# CITY PLANNING COMMISSION

APPLICATION: A. Negative Declaration  
B. Special Permit to develop 250 townhouse units.  
C. Special Permit to allow one project identification sign.

PROPOSAL: The applicant is requesting the necessary entitlements to construct 64 one bedroom and 186 two bedroom townhouses.

APPLC.NO. P87-411 MEETING DATE October 22, 1987 ITEM NO 21

# PROJECT IDENTIFICATION SIGN

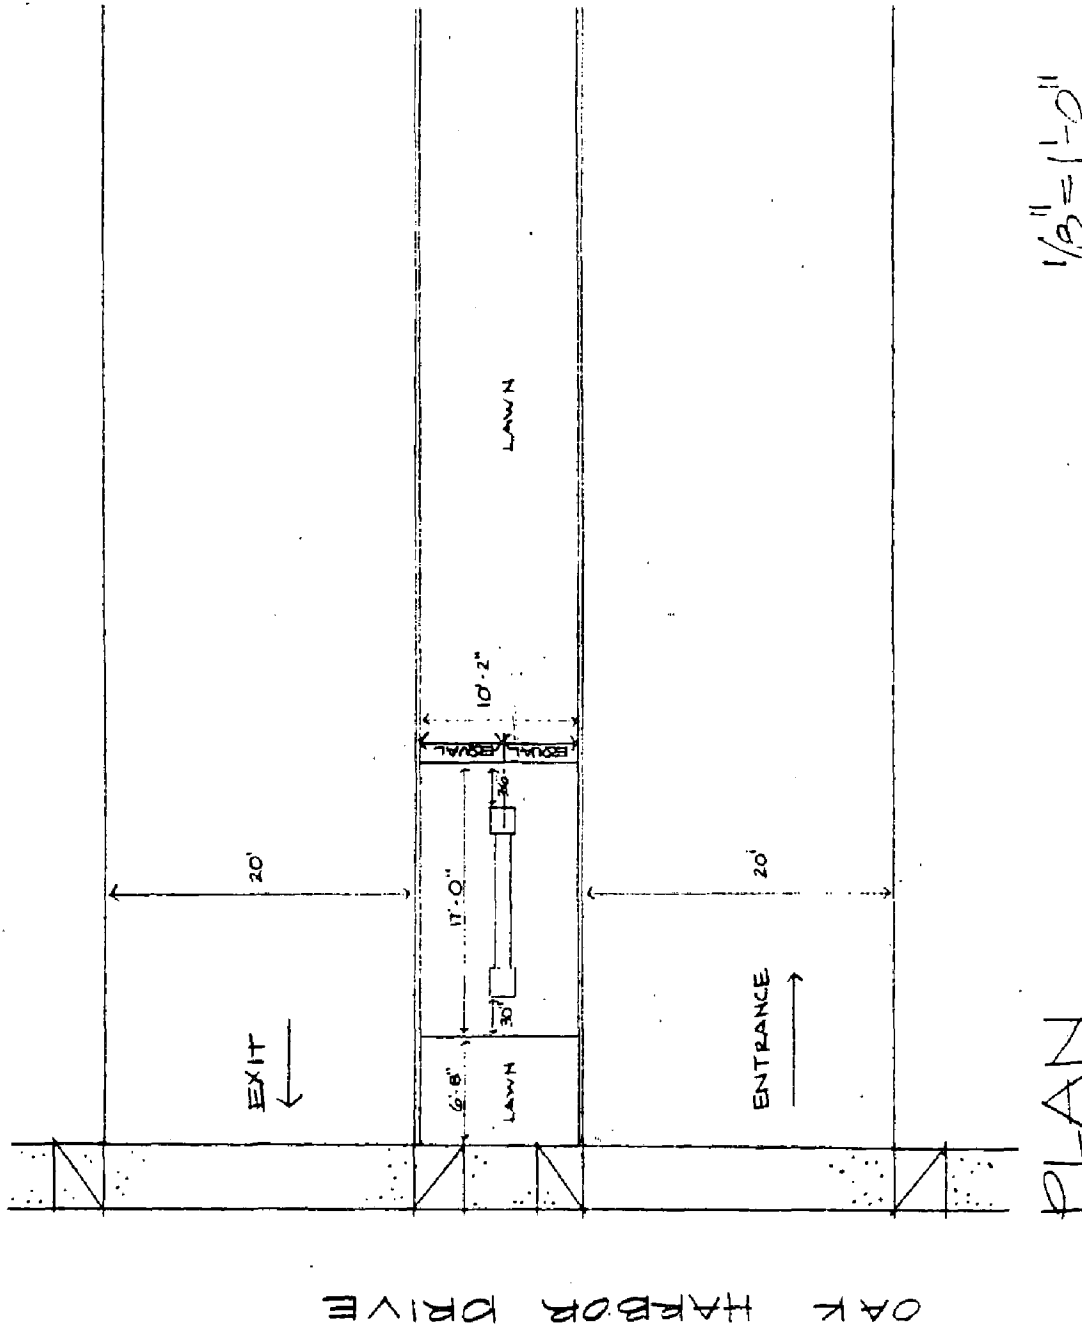
The applicant is requesting a special permit to allow one project identification sign to be located at the main entrance on Oak Land Drive (see site plan). The applicant has indicated this project identification sign will be similar in height, area and building materials as the existing brick monument identification sign for the Phase I development located to the north (see project identification sign exhibit). Staff notes the proposed location of the sign is nine feet from the public right-of-way. Staff recommends this sign be located more than ten feet from the right-of-way as required by the sign ordinance. Staff has no objection to the proposed sign provided the following requirements are met:

1. A project identification sign shall be a monument type sign or incorporated into a low profile decorative entry wall(s).
2. The height of the monument sign shall not exceed six (6) feet.

3. The project identification sign(s) may be placed in the landscape setback area; however, it must be located farther than 10 feet from the public right-of-way.

4. The primary material of the monument base or wall shall be decorative masonry, such as brick, split face concrete block, stucco, or similar material which compliments the design of the main building (s).

5. Individual or script letter type and project logo are examples of acceptable sign design. Back lit canned plastic signs are not permitted.
6. If the project identification sign is placed on a free-standing monument base, a double faced sign is permitted. If the project identification sign is affixed flat against a wall, one single-faced sign on each side of the driveway is permitted.

7. The maximum area of sign devoted to sign letters (excluding logo) shall be 12 square feet per sign.

1. No more than one project identification sign is permitted per street frontage.
2. A project identification sign shall be a monument type sign or incorporated into a low profile decorative entry wall(s).
3. The height of the monument sign shall not exceed six(6) feet.
4. The project identification sign(s) may be placed in the landscape

setback area; however, it must be located farther than 10 feet from the public right-of-way.

5. The primary material of the monument base or wall shall be decorative masonry, such as brick, split face concrete block, stucco, or similar material which compliments the design of the main building(s).
6. Individual or script letter type and project logo are examples of acceptable sign design. Back lit canned plastic signs are not permitted.
7. The maximum area of sign devoted to sign letters (excluding logo) shall be 12 square feet per sign.
